**Planning, Zoning & Economic Development  
Memorandum**

**DATE:** January 11, 2022  
**TO:** Members of the Planning and Zoning Board  
**THRU:** Danny A. Holmes, AICP   
Planning, Zoning & Economic Development Director  
**FROM:** Lisa Zelch, Senior Planner

- A. Project Name / Number: 8601 W. Sunrise Redevelopment / PP20-0016
- B. Requests:
  - 1. Assignment of 367 flexibility / reserve units; and
  - 2. Allowance of 25 affordable housing bonus units; and
  - 3. Rezoning from B-7Q Planned Commercial Development District to B-8Q Planned Residential Commercial Development District; and
  - 4. Conditional use approval to allow multi-family residential development, office, and retail uses in a B-8Q zoning district; and
  - 5. Site plan, elevations and landscape plan approval to permit the development of 392 multi-family dwelling units, 103,766 square feet of office use, and 5,000 square feet of commercial use.
  - 6. The applicant is requesting 6 zoning waivers from Chapter 27 of the City Code and 1 landscape waiver from Chapter 13 of the City Code. See Exhibit E.

Building 3 site plan:

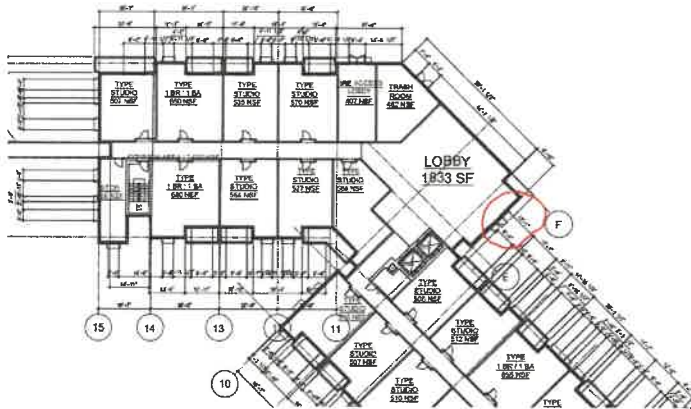
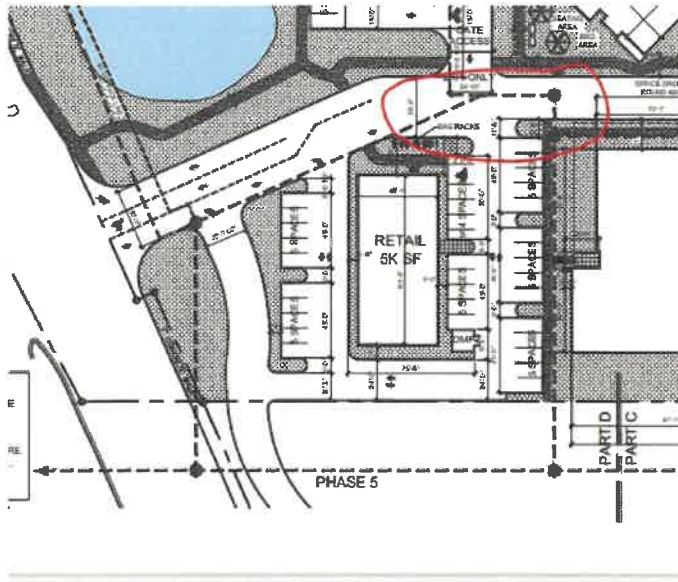
2. The site plan, floor plans, building elevations, and renderings are inconsistent throughout the plan set which does not allow staff to do a complete review.

Applicant Response: Applicant has taken care to eliminate inconsistencies with this updated submittal.

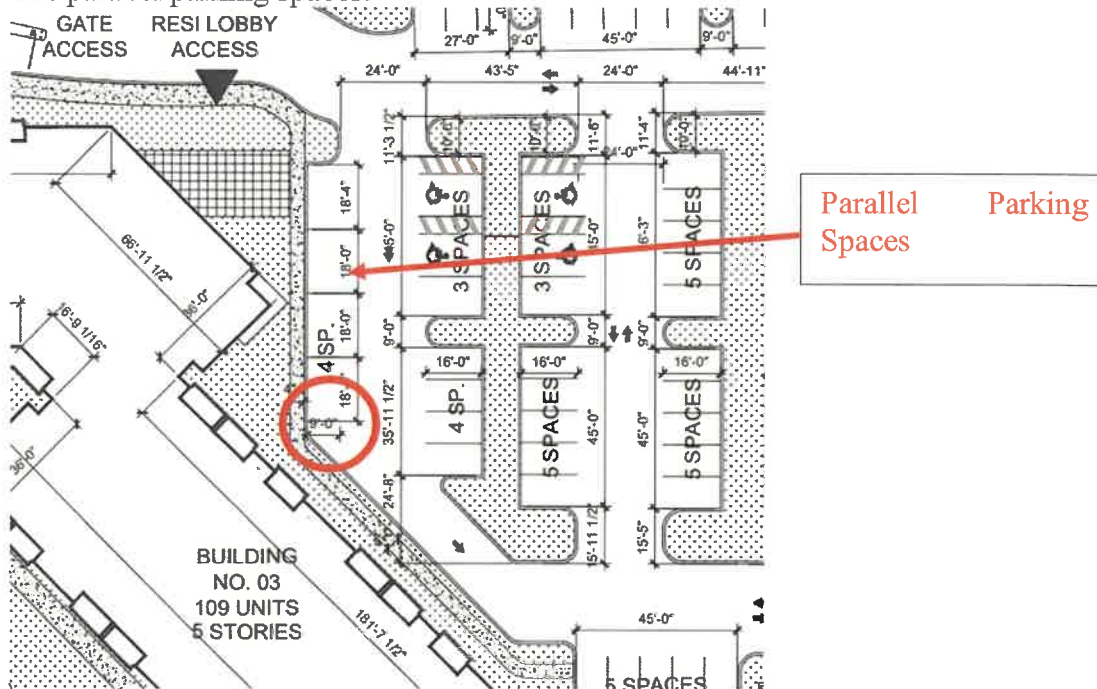
19. Staff calculates 10 loading zones are required (8 for the residential use and 2 for the office use).

(Section 27-747(d)). **The applicant is requesting a waiver**

a. Three loading zones are provided for the office building only.

b. Code requirement is that each loading zone is a 12’X45’ dedicated space for loading. There are 2 loading zones on the ground floor of the office building that do not meet the length requirement, with a length of 38-feet 10-inches. **This waiver is required and has not been requested.**

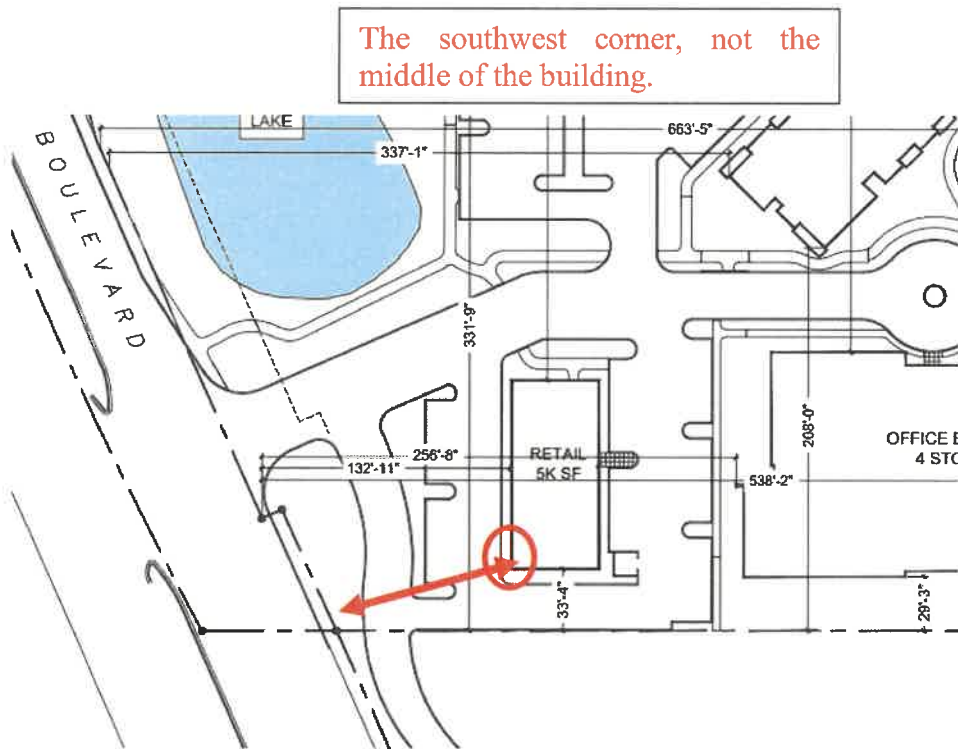
- a. Parallel spaces minimum size requirement is 9-feet by 23-feet, not 9-feet by 18-feet (27-742(b)(4)). Provide the correct dimensions, this will reduce the provided parking by one space.
  - b. Add a landscape area to the east of the parallel parking section.
  - c. Ninety-degree parking requires a 25-foot two-way drive aisle, not a 24-foot one way drive aisle (Section 27-742(e)).
22. Provide the civil plans at a larger scale, similar to the architectural site plans and landscape plans, in addition to the overall site plans provided.

Staff Response: See the example below clarifying the comment. Building 1 Site plan:

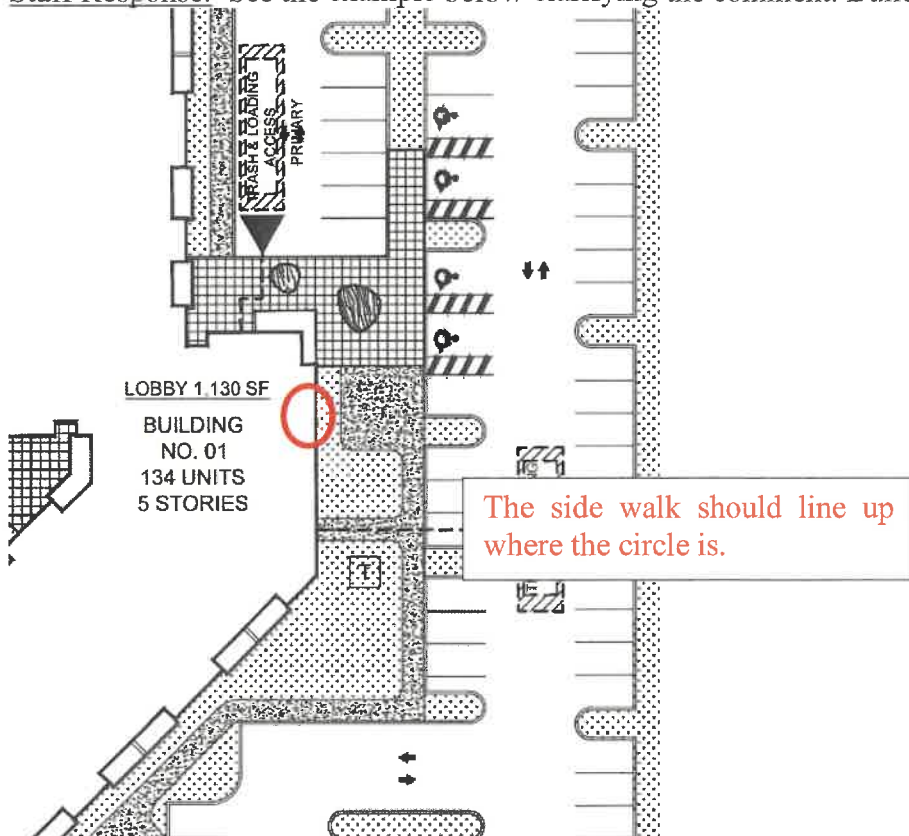
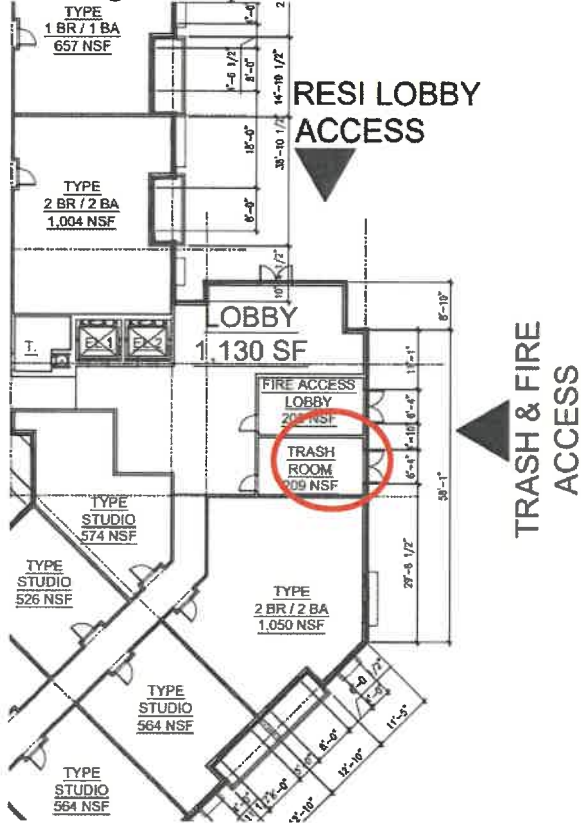
- a. The site plan does show trash access points for each building, but these points, with walkways, etc. do not match the location of the trash rooms on the floor plans. This is the case for residential Buildings 1 and 2. Make the necessary corrections.

Applicant Response: Applicant has allocated two spaces for moving/loading and trash removal for each residential building. Applicant has strategically placed these areas in locations where we do not block traffic and secondary traffic can generally pass without restrictions. Applicant has reviewed the plan with Waste Management and will seek Waste Management approval of our City Council submittal.

**Sheet A1.7:**

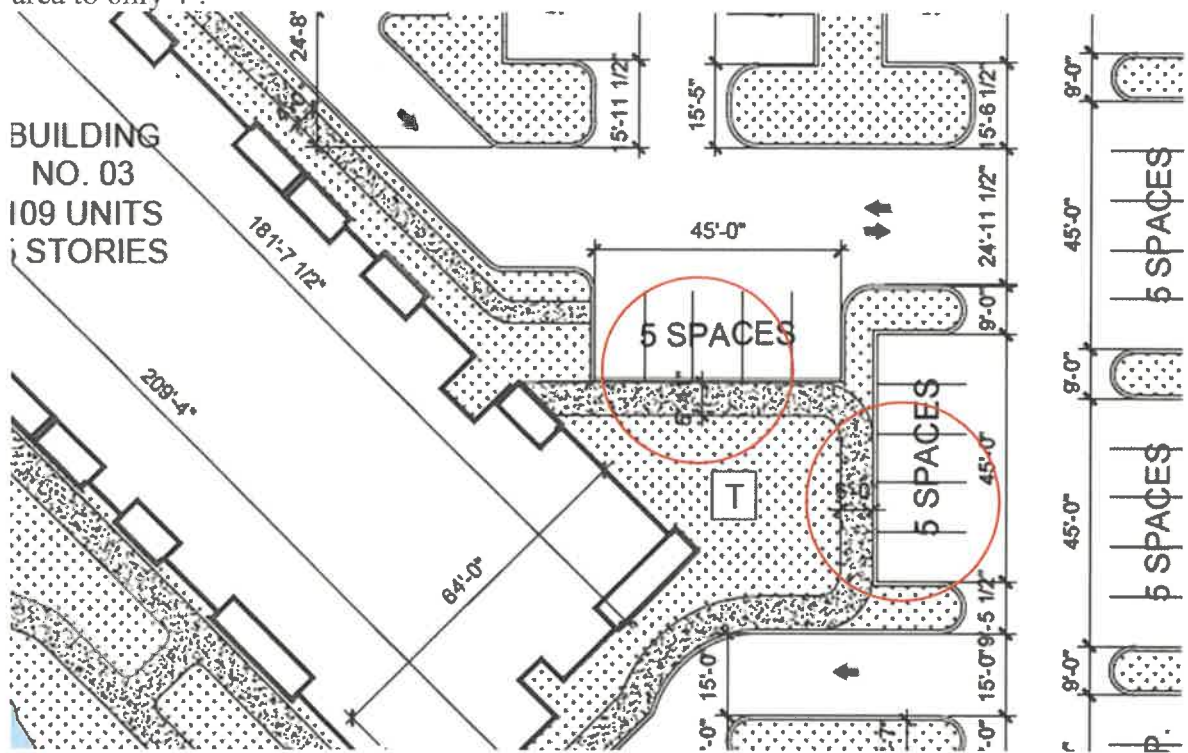
1. Please clarify if the western gate will be dedicated residents only, if yes, then signs need to be provided. If no, then note that no guest lane nor turn-around area was provided for any vehicle denied entry which will result in longer queuing.

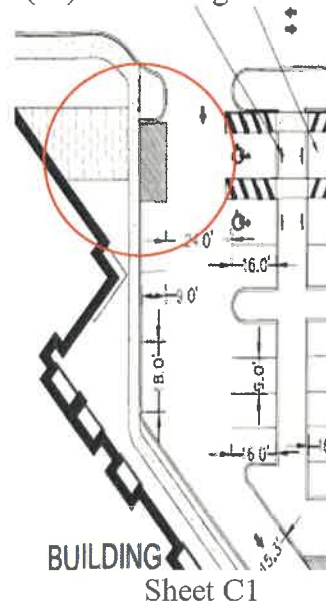
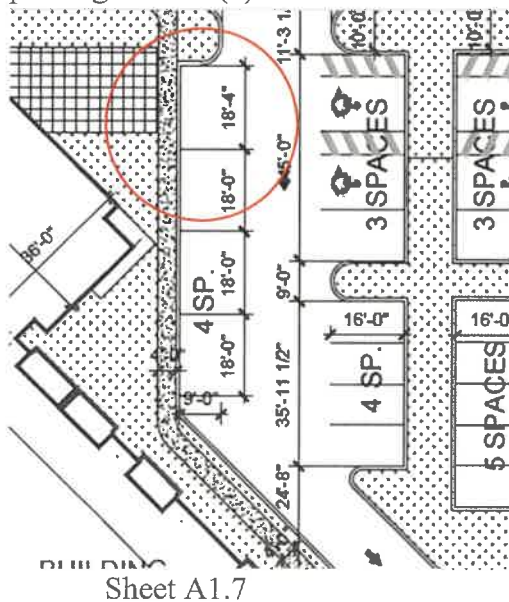
- Even though the sidewalk was depicted at 6', the parking overhang will limit the walkable area to only 4'.

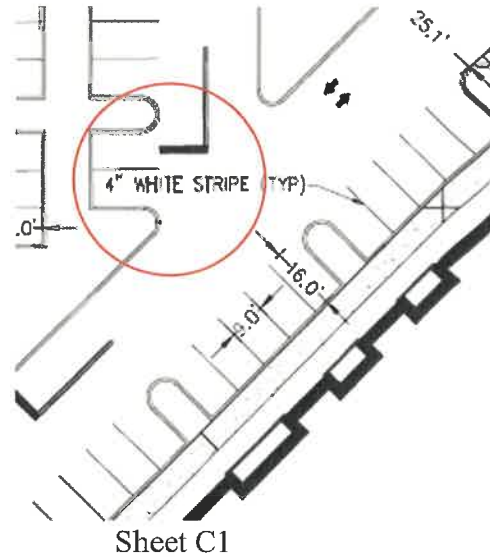
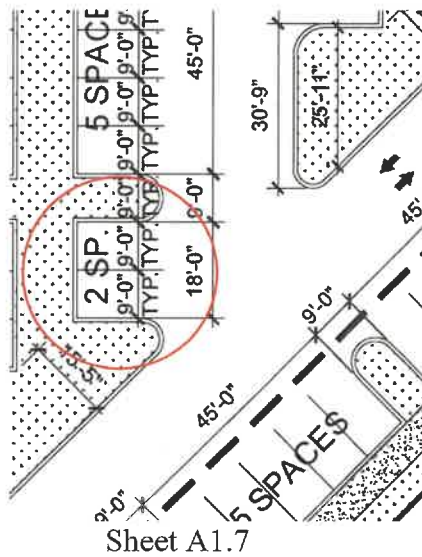
- The 4-parking spaces adjacent to building # 3 is not consistent with the civil plans. In addition, City of Plantation Code of Ordinance Section 27-742.a.4 requires that parallel parking be nine (9) feet in width and twenty-three (23) feet in length.

**Sheet A1.8:**

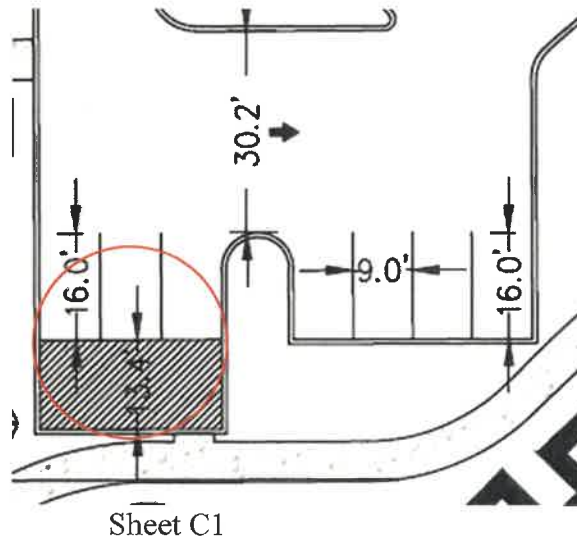
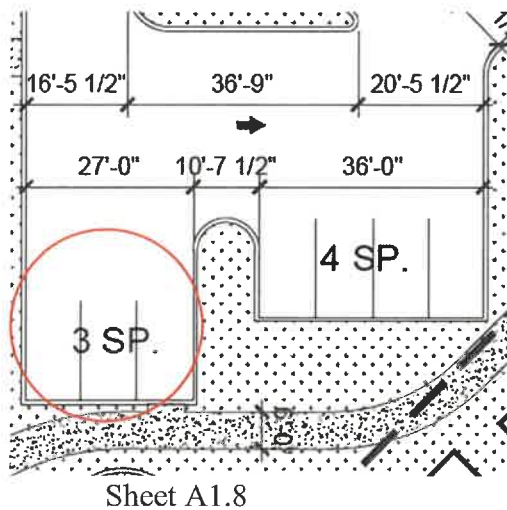
5. Provide the dimension of the 3- parking spaces abutting the putting green and identify the function of the excess paved area.

**Sheet A1.10:**

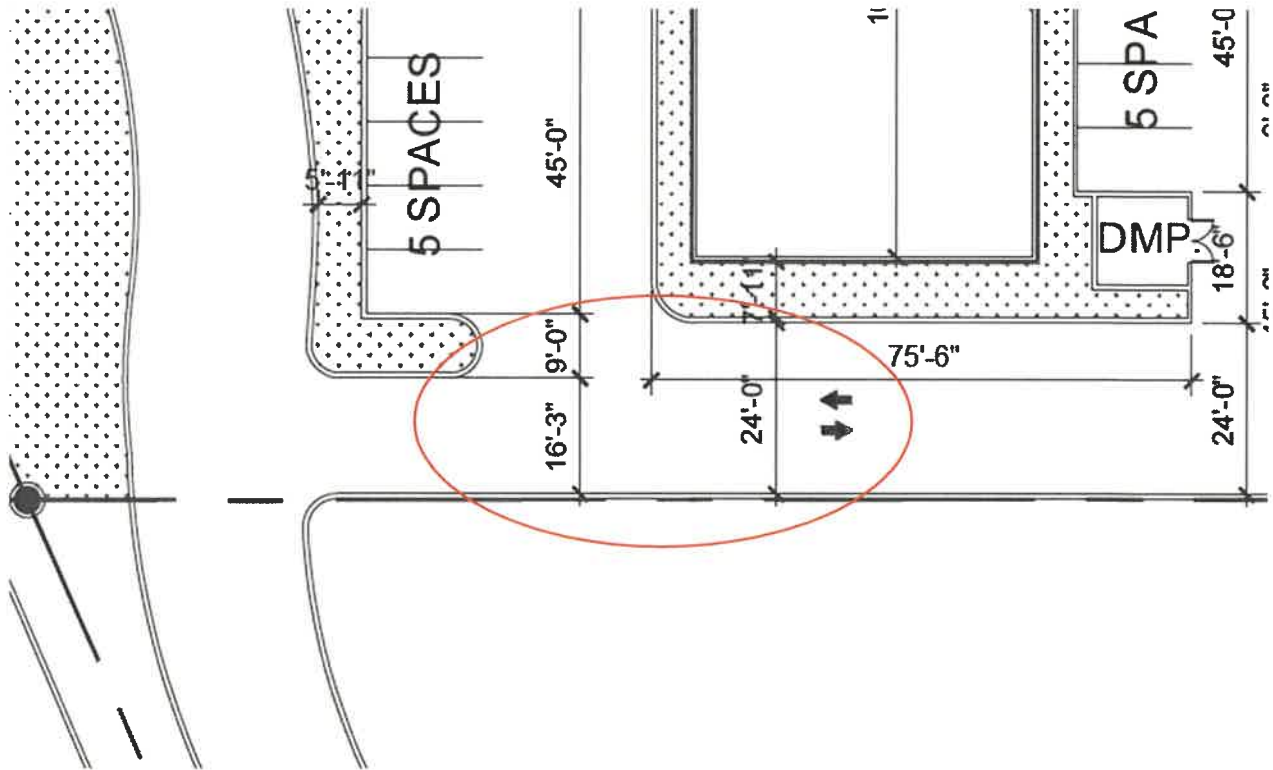
7. Please add dimensions of all parking spaces and all abutting sidewalks to ensure minimum 4 feet walkable area after deducting the parking overhang.
8. Drive-aisle (at the eastern boundary of the sheet) transitions from 24' to 16' then converges again onto the two-way traffic. Please clarify the choke point area.

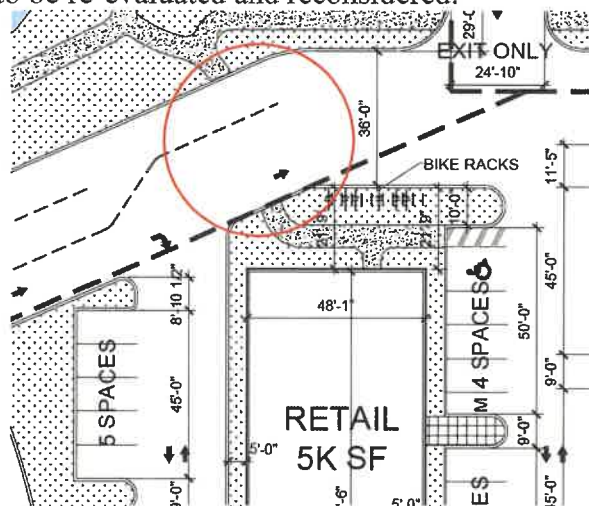
9. The sidewalk connection between the retail building and the surface parking seems to be unsafe and needs to be re-evaluated and reconsidered.

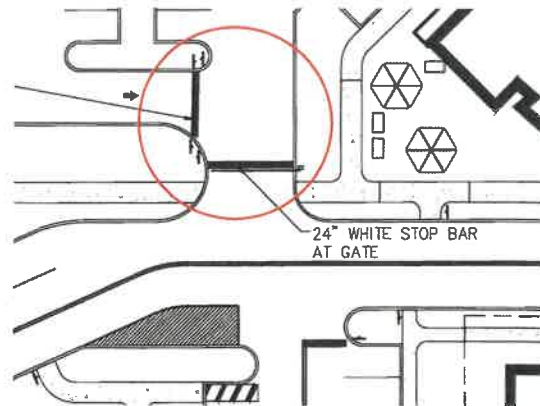
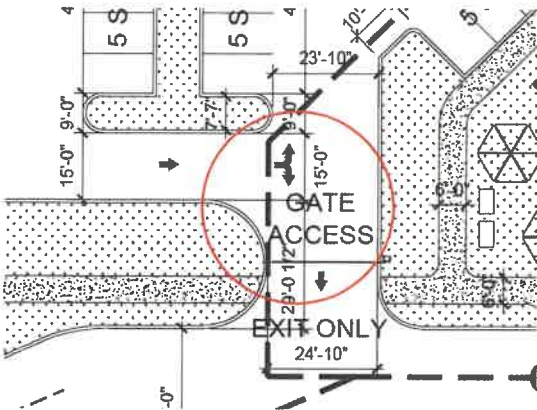
- Provide stacking analysis to support the location of the exit only gate. The location of the gate seam will create a conflict in traffic circulation at that area.

**Sheet C1:**

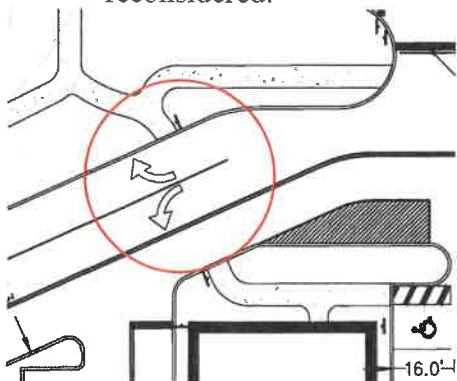
- Sheet A1.3 shows 4 parallel parking spaces adjacent to building # 3 while sheet C1 shows 3 and one hatched. Please clarify. See comment # 3 above.
- The north arrow is not consistent between the civil and the architectural drawings.
- One-way dimension abutting building # 3 is depicted at 15.3' and did not meet the 16' required for fire access.
- Please clarify the hatched areas throughout the parking lot next to select medians. Please add areas to the median and expand the pervious areas.
- All pedestrian crossing markings need to be identified on the plan. All pedestrian crossing along the eastern entrance does not appear to be safe and needs to be re-evaluated and reconsidered.

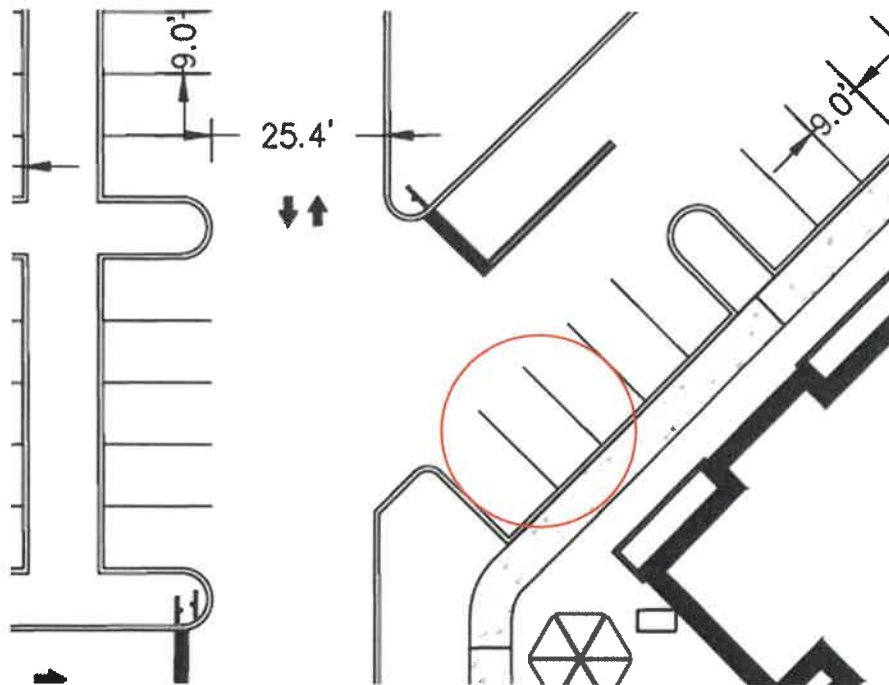
- The last 3-parking spaces abutting building # 2 seem in conflict with the incoming traffic. Please re-evaluate the traffic circulation around this area.

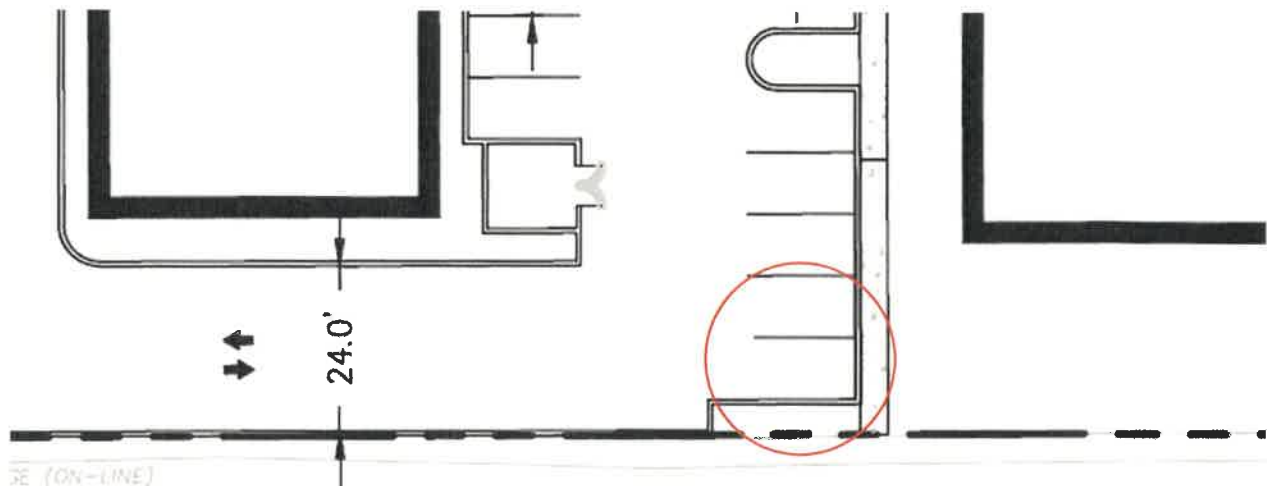
20. Stop bar throughout the site needs to be offset 4' behind the sidewalks.
21. Civil plans need to show more detail on the function of the office building drop-off area including all pavement markings and signage required for proper traffic circulation.
22. Re-evaluate the first two parking spaces adjacent to the office building. Vehicles waiting to exit this drive isle is in conflict with the first 2-parking spaces.

**Sheet C2:**

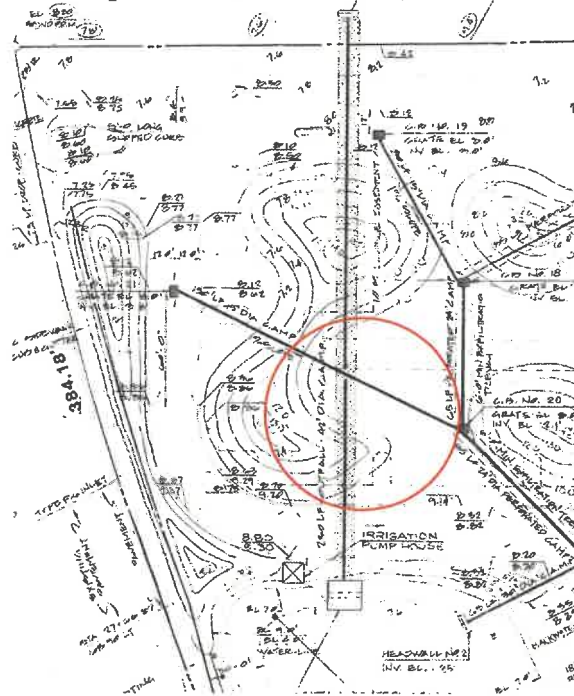
25. An inspection of the existing lake showed invasive vegetation growth, please identify action plan to restore the lake to its original capacity.

26. Drainage calculation summary indicates that the minimum finish floor elevation is set at 8.5 NAVD, however, the parking garage elevation is set at 7-7.5 NAVD on sheet C2. Please clarify and revise accordingly.
27. The drainage as-built of the existing outfall pipe is shown as 42". The new outfall pipe is proposed to be 24". Please provide hydraulic analysis to ensure proper pipe sizing.
